Date: 02 May 2025

Respond to Request Further Information 2 September 2024

Private Plan Change Request (Ref: PC0003/23) – Coniston Park Ltd, Farm & Racecourse Roads, Ashburton

CROSS SECTION - OUTLINE DEVELOPMENT PLAN

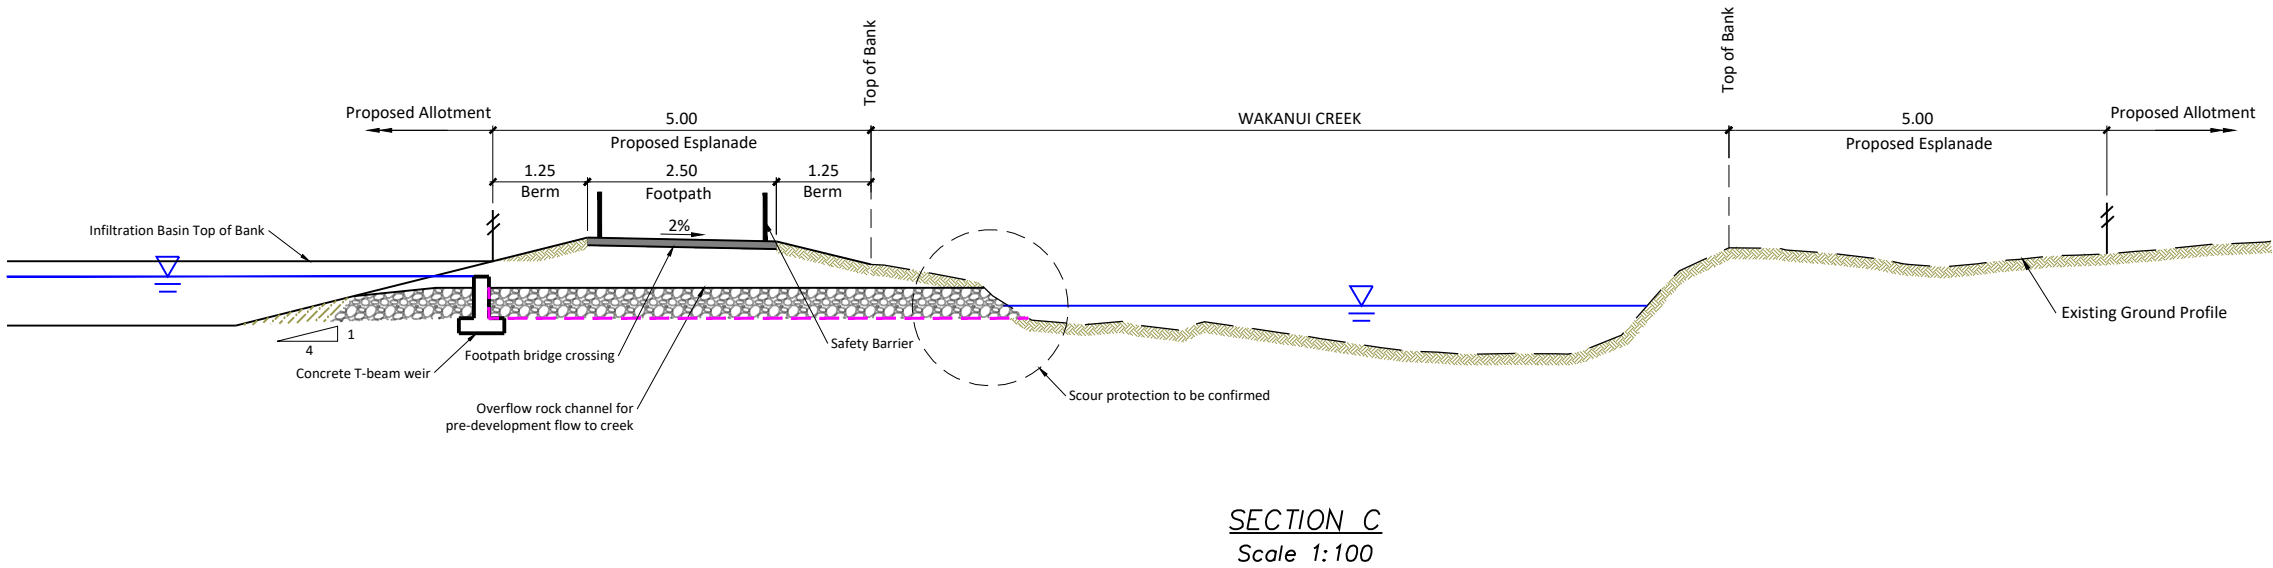
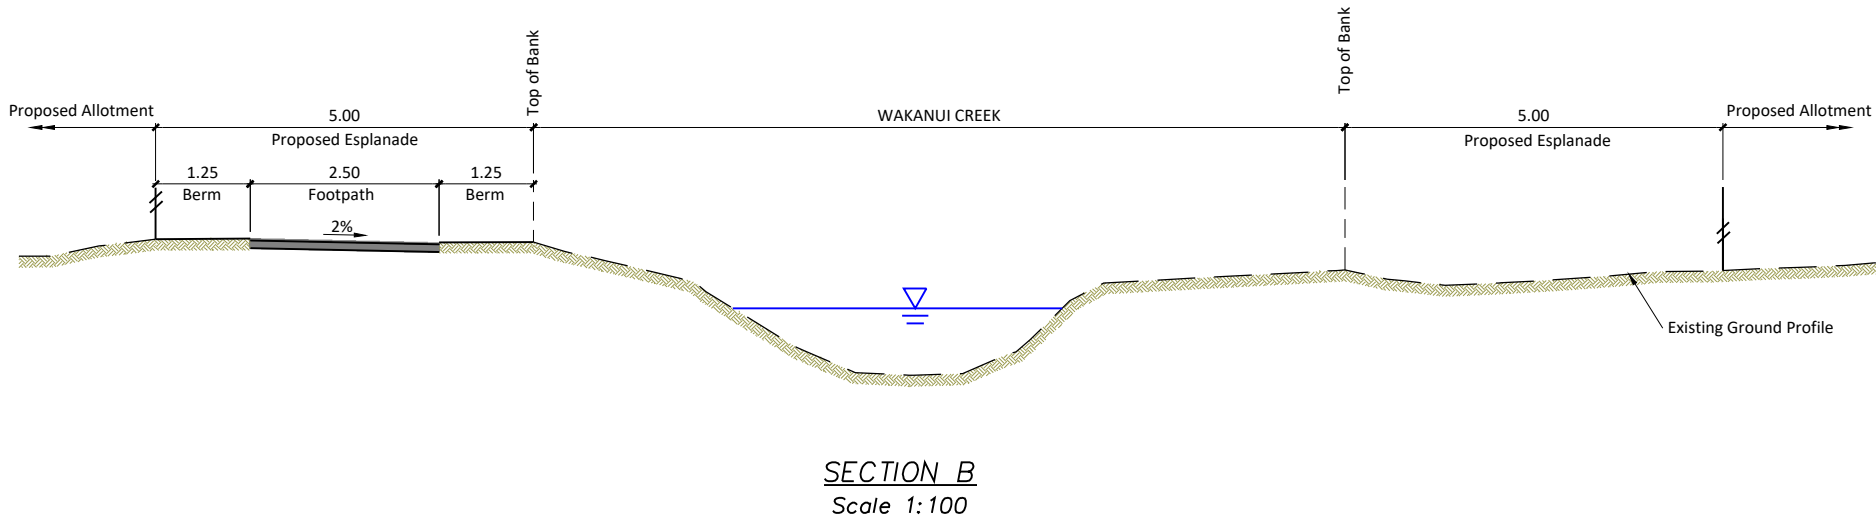
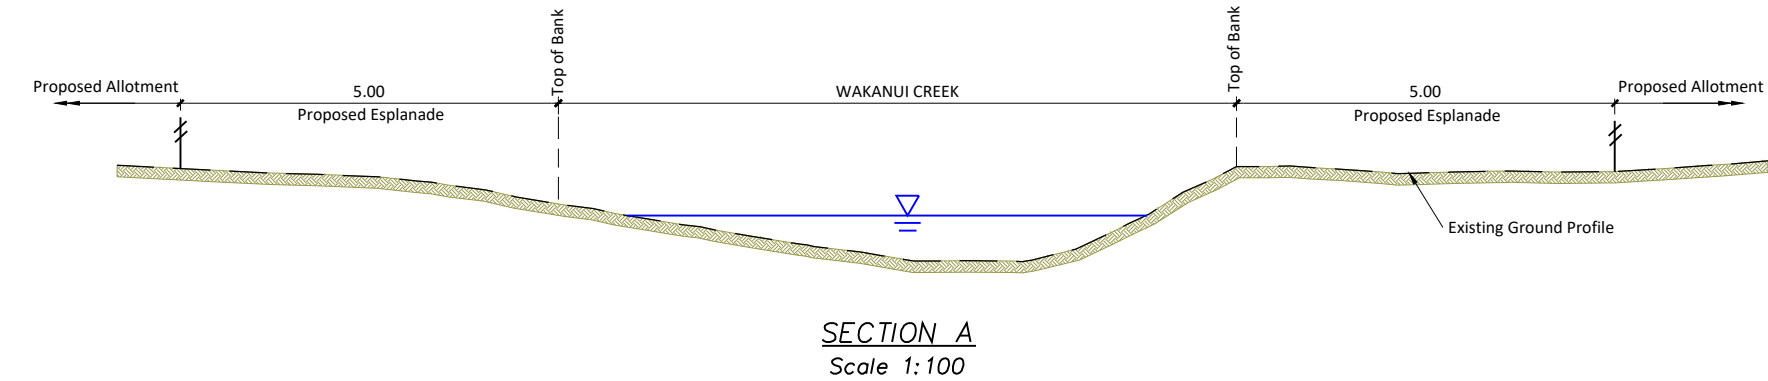
9. For the proposed reserve area adjoining Wakanui Creek, please provide cross sections of the creek and esplanade reserve (near Lots 26 and 48 on the Subdivision Layout Plan) so that the appropriate width for this reserve can be determined and agreed prior to the finalization of the ODP.

- g. **The proposed reserve area adjoining Wakanui Creek should be labelled as an 'Esplanade Reserve' and details of its width should be included on the ODP (noting this links to the earlier request to provide cross sections in order to determine appropriate width for this reserve before the ODP is finalized).**

Refer to Plan OP03 – Cross Section – Outline Development Plan in Appendix C

Refer to Plan OP03 - Cross Section – Outline Development Plan in Appendix C to show the appropriate widths and cross sections respectively at the Esplanade Reserve.

APPENDIX D – ASHBURTON URBAN STORMWATER STRATEGY HYDRAULIC MODELLING PLANS (FEB 2015)

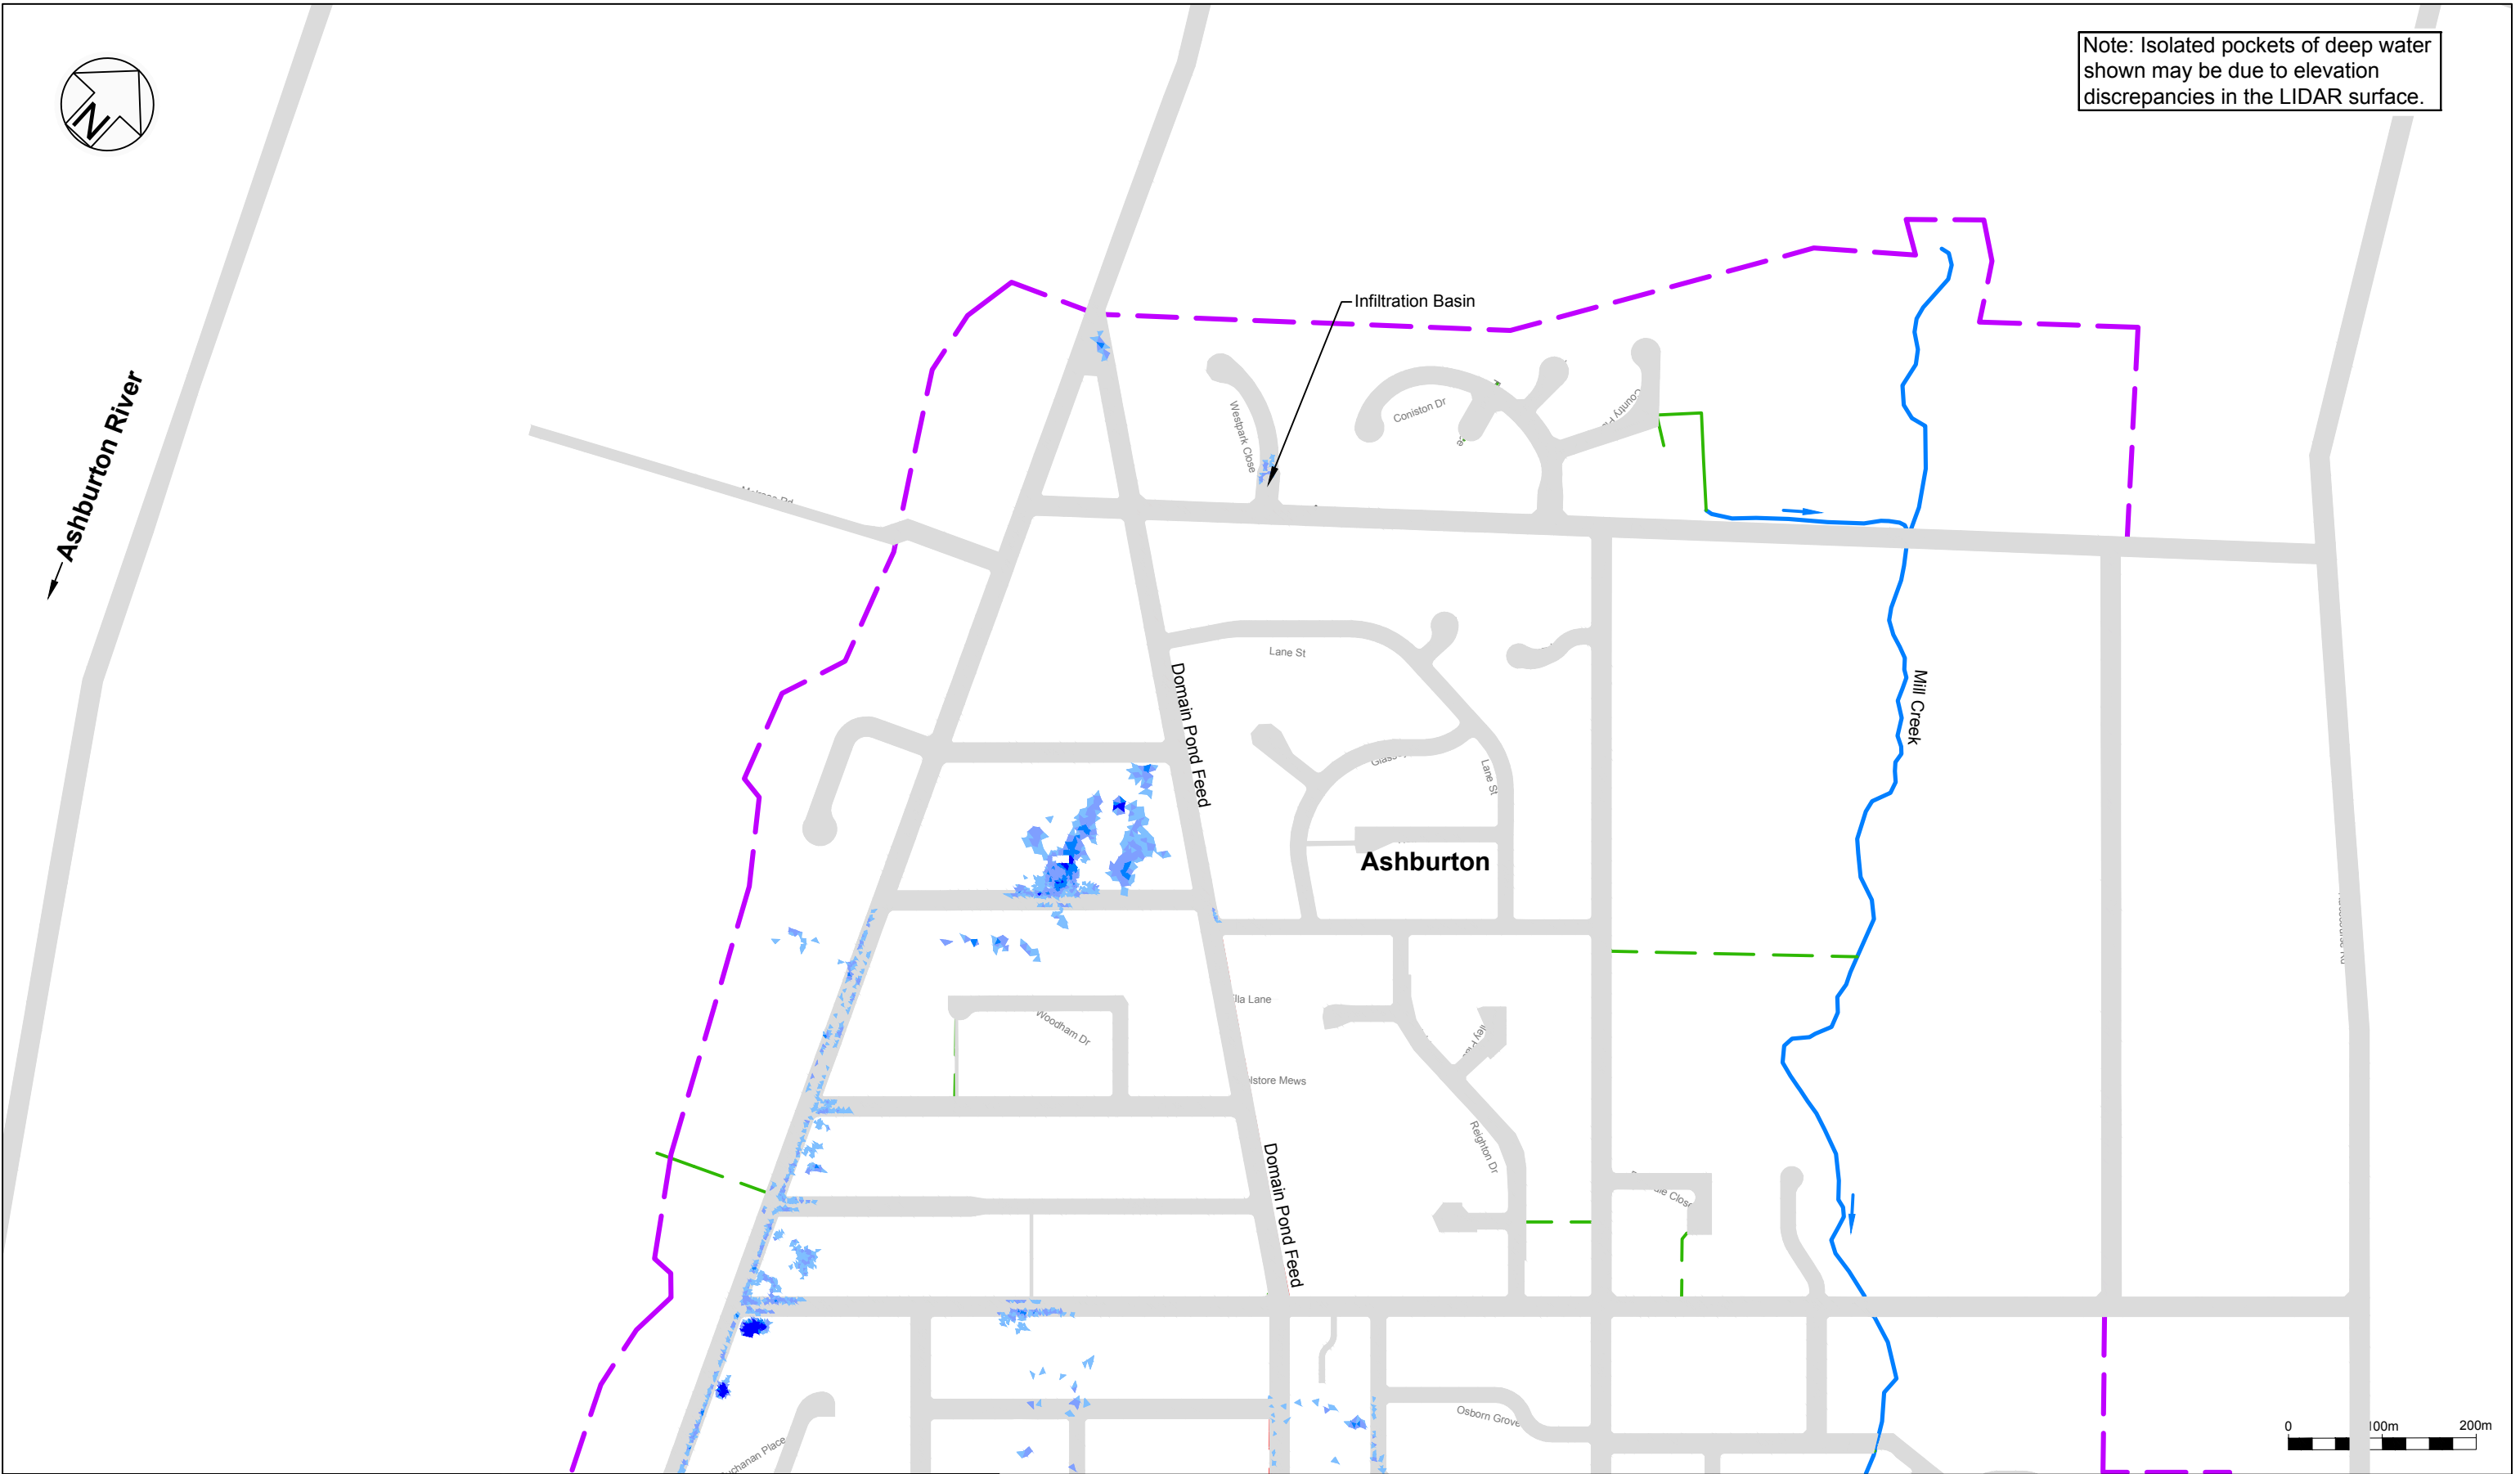
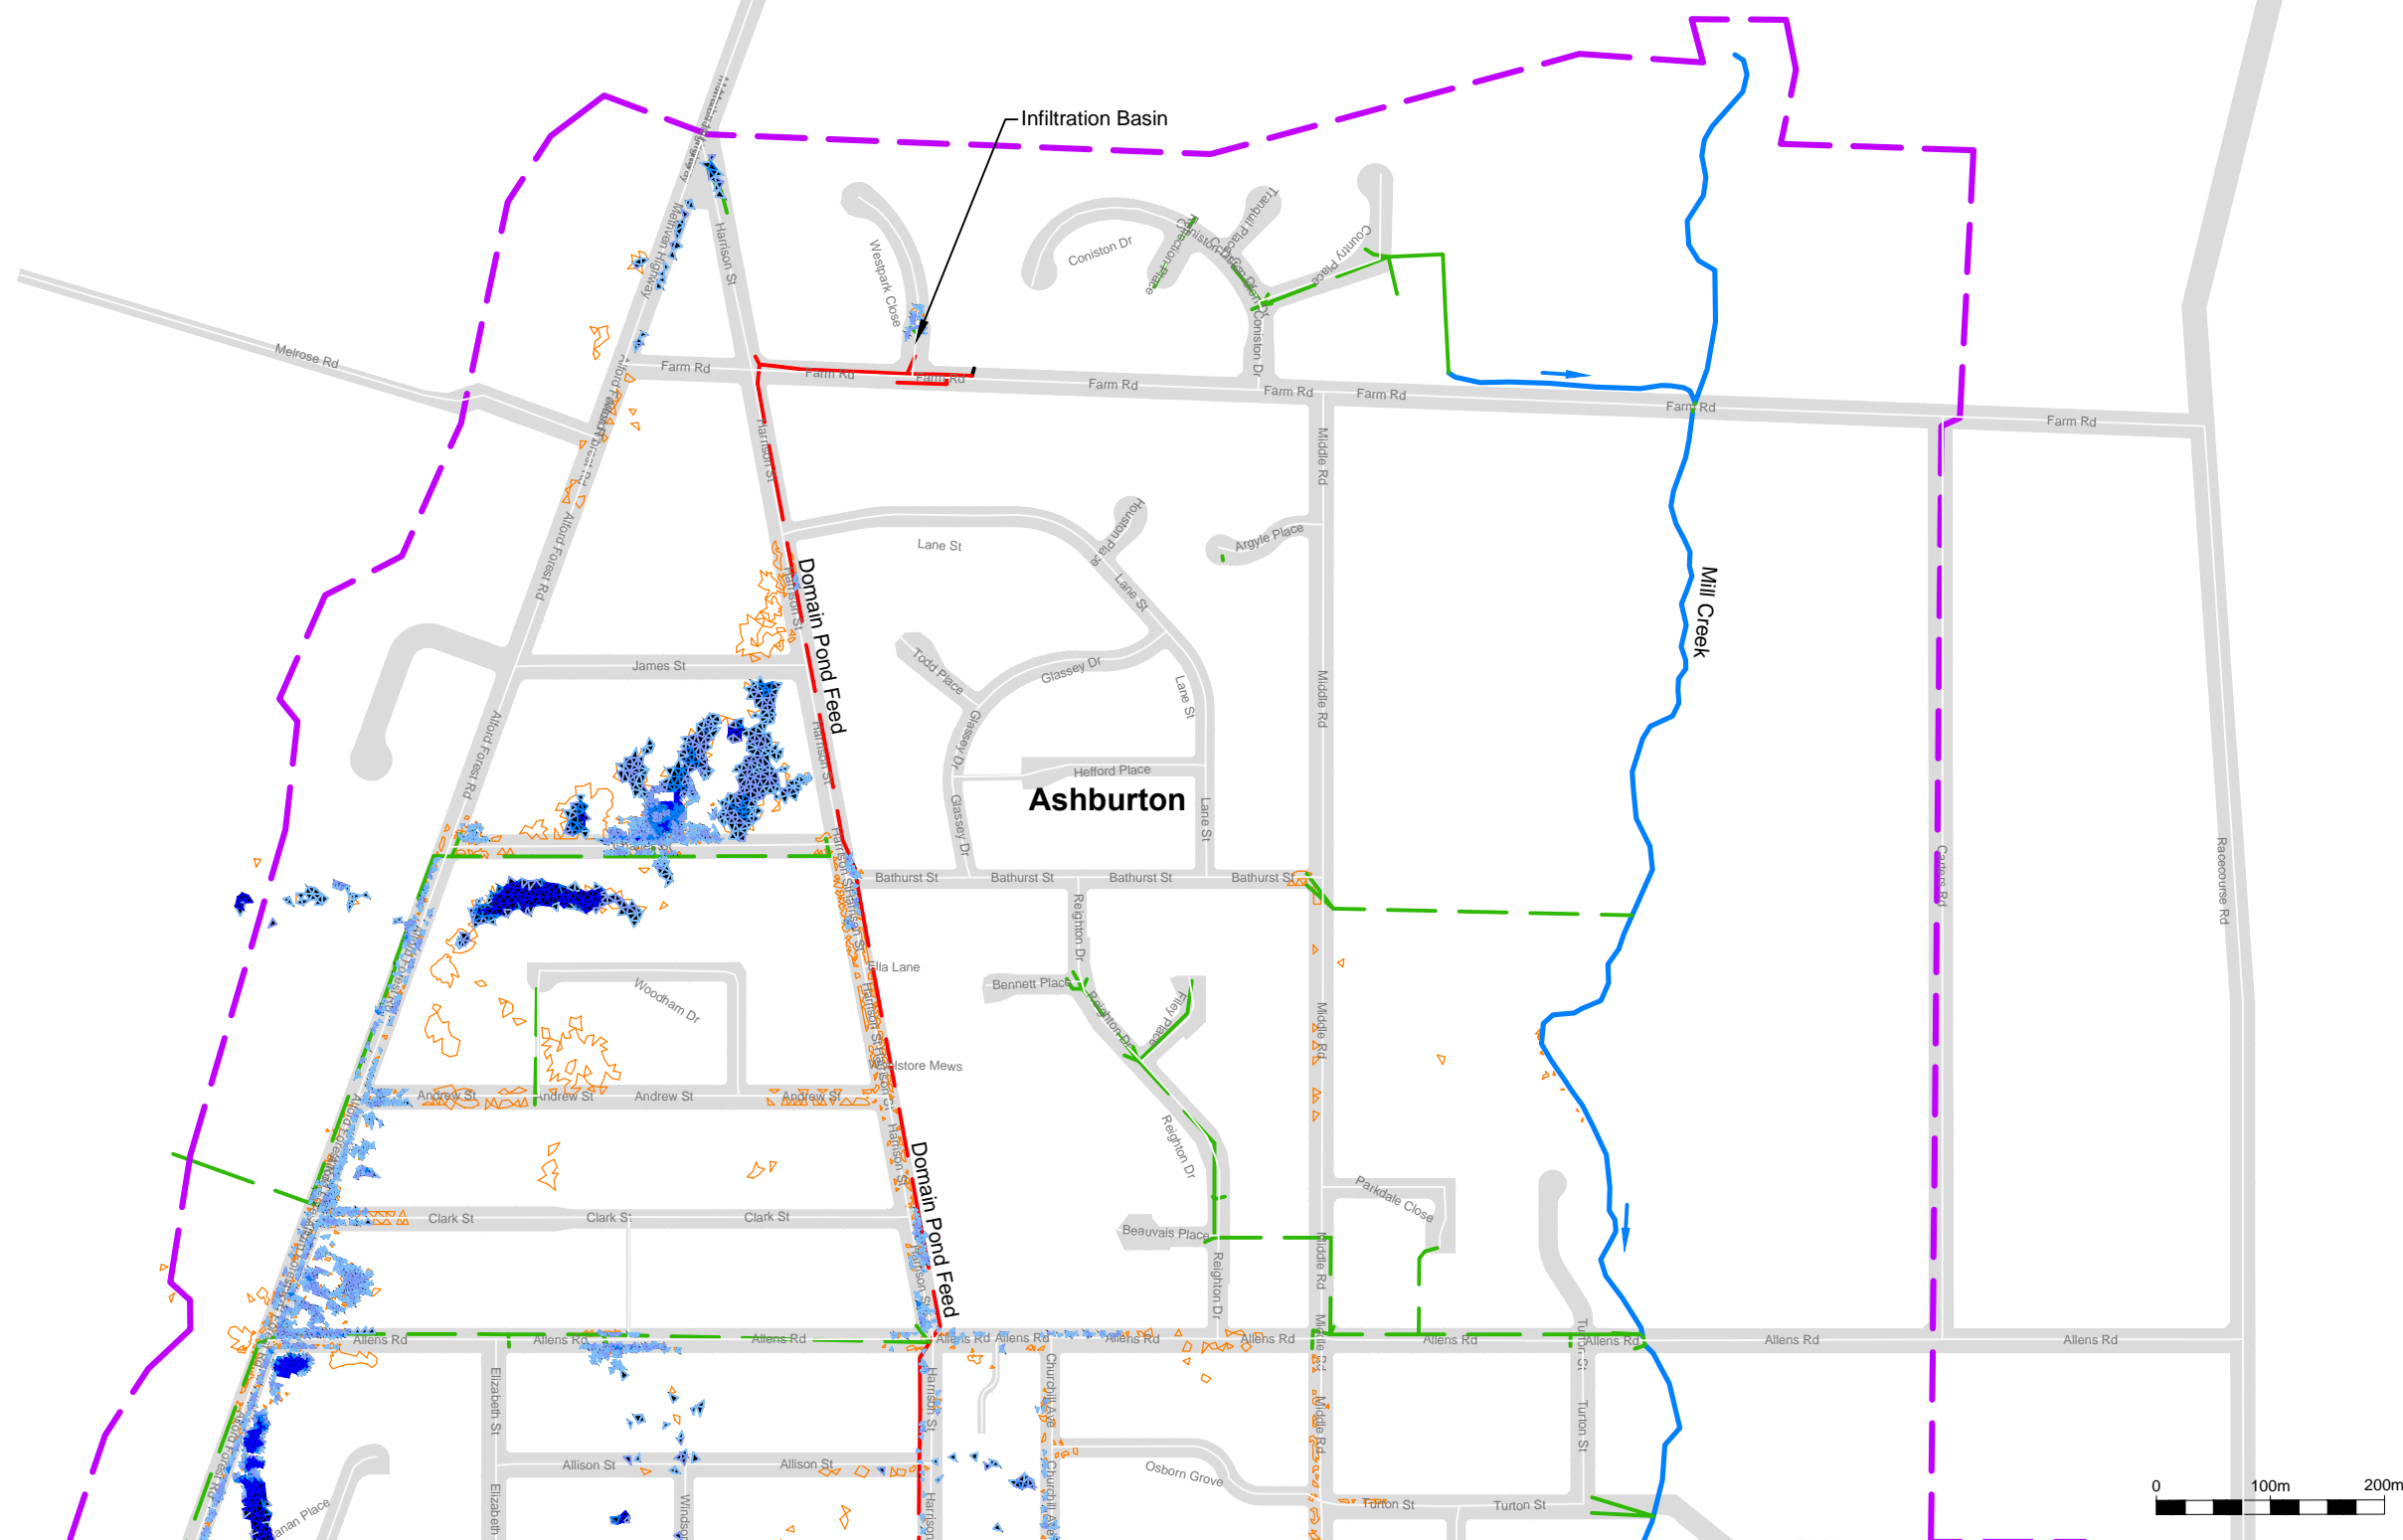
- **Future design for the waterway will need to look at culvert(s) crossing the Wakanui Creek and the flood capacity of the waterway.**

The stormwater design for the post-development discharge is no greater than pre-development for all rain events up to 2% AEP 48hr duration and therefore is not required to do so.

According to Ashburton Urban Stormwater Strategy Hydraulic Modelling Plans (Feb 2015) supplied by ADC the culvert across Farm Road and the stream maintains the flood water within Wakanui Creek both upstream and downstream of the culvert. This demonstrated there is sufficient flood capacity within the area.

Please refer to Ashburton Urban Stormwater Strategy Hydraulic Modelling Plans (Feb 2015) in Appendix D for the 10%, 2% and 1% AEP 48hr duration model output plans.
